VILLAGE OF WILLIAMS BAY

ZONING BOARD OF APPEALS (ZBA) MEETING

TUESDAY, JUNE 20, 2023 AT 6:30 PM

Applicant requests a variance to zoning code section 390-0212 to separate Lot 6 from Lots 4 and 5, resulting in a proposed side yard setback of 8.5 feet (minimum of 10 feet required). Note that the existing screen porch will be removed.

PLAT OF SURVEY

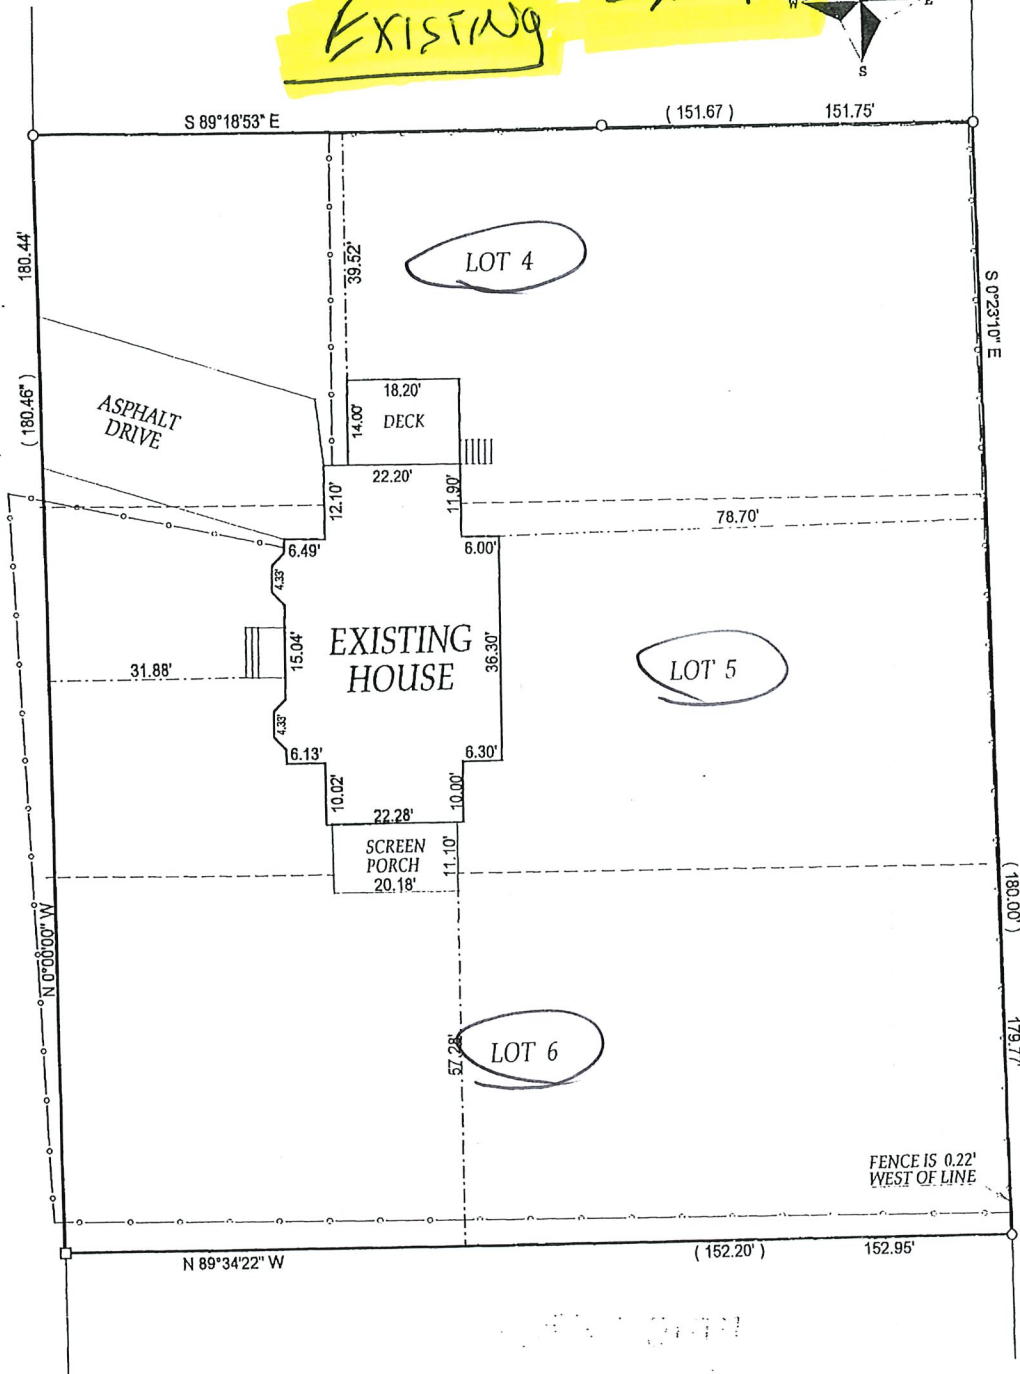
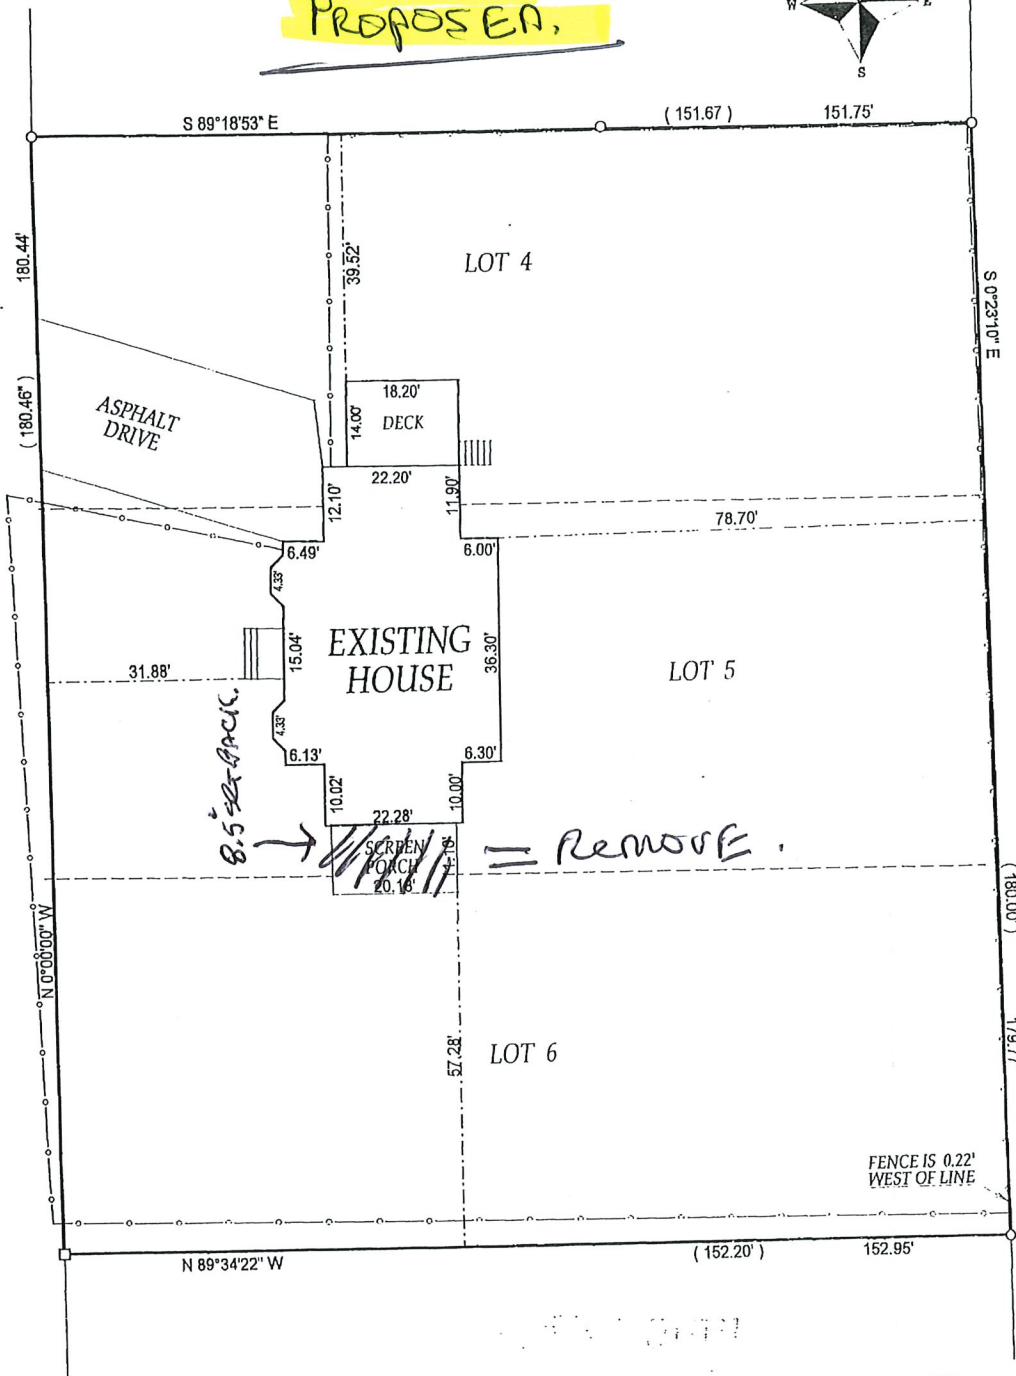
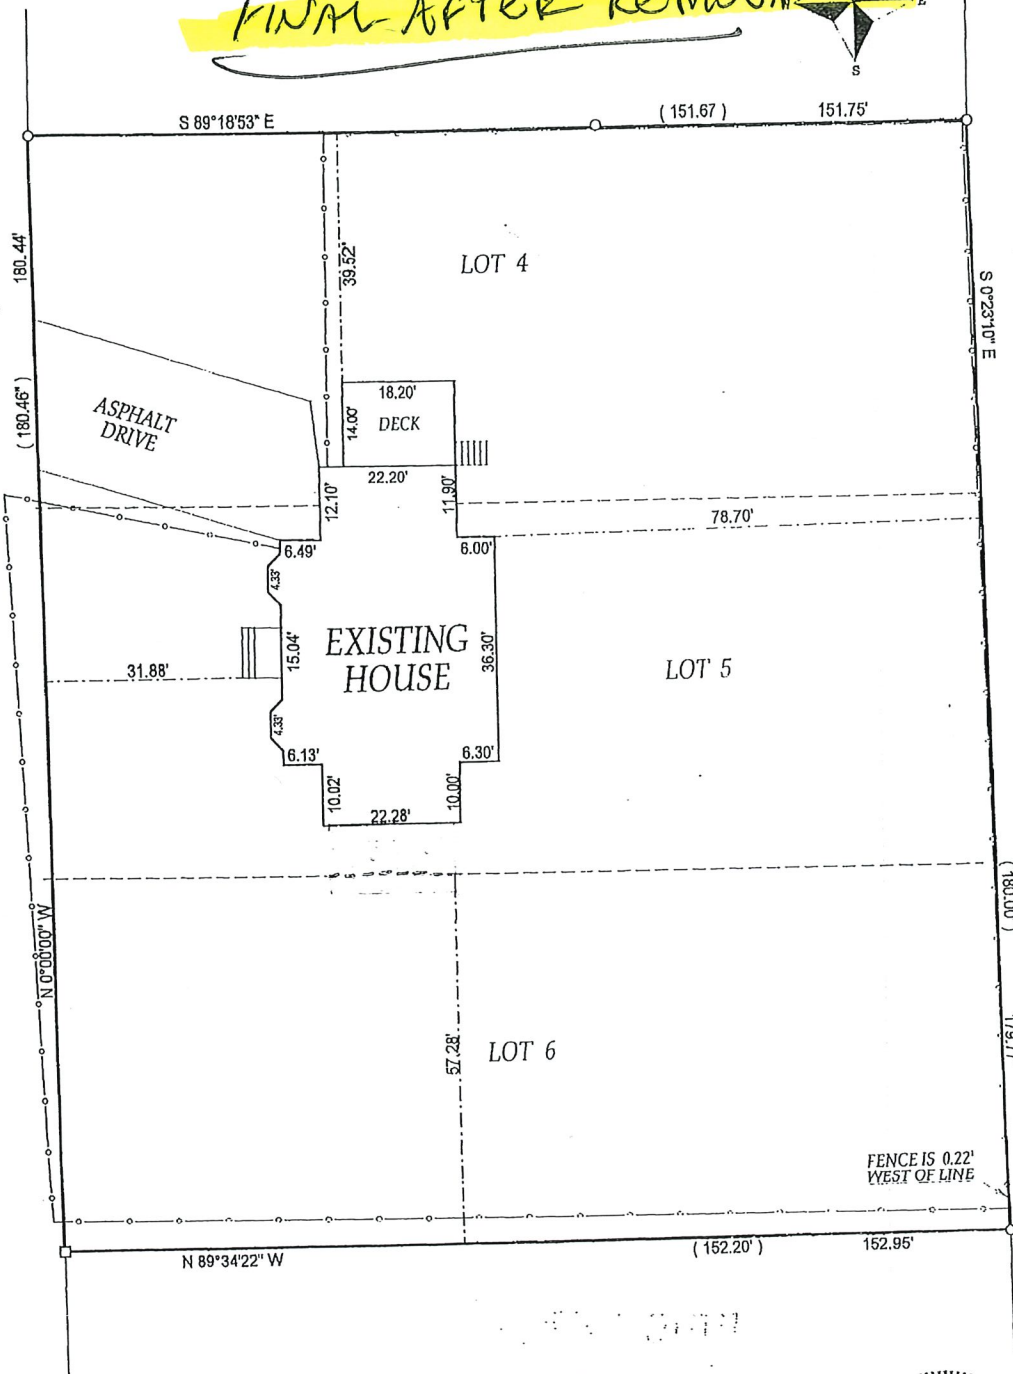
I am planning on doing some updating of my home at 65 Cedar Point. My home sits on 3 lots. Lot 4, 5, and 6. I plan to remove my 3 seasons porch on the south side of Lot 5 as it is in poor condition. This will allow for a setback of approximately 8.5 feet from the south lot line of Lot 5.

After completion of the tear off of the 3 seasons room I will then subdivide Lot 6 from lot 4 and 5.

The current hardship was created when the 3 seasons porch was added and encroaches on Lot 6. In addition, in order to make the house 10 feet off the lot line of Lot 5 I would need to also remove a full bath and a small office area in order to meet the 10-foot setback requirement which I prefer not to have to do. This would be a hardship. I am not adding to the home I am merely reducing it.

- The hardship is peculiar to the subject property since the home was constructed prior to passing of the current zoning regulations.
- The requested variance is essential to make the subject Lot 6 developable. Lots 4, 5, and 6 are individually legal lots of record.
- The proposed development does not appear to have any substantial impact on adjacent properties.
- The development will have no substantial impact on the neighborhood's character as it is consistent with location and size of development on adjoining lots.
- The proposed development does not conflict with the Village Comprehensive Plan.
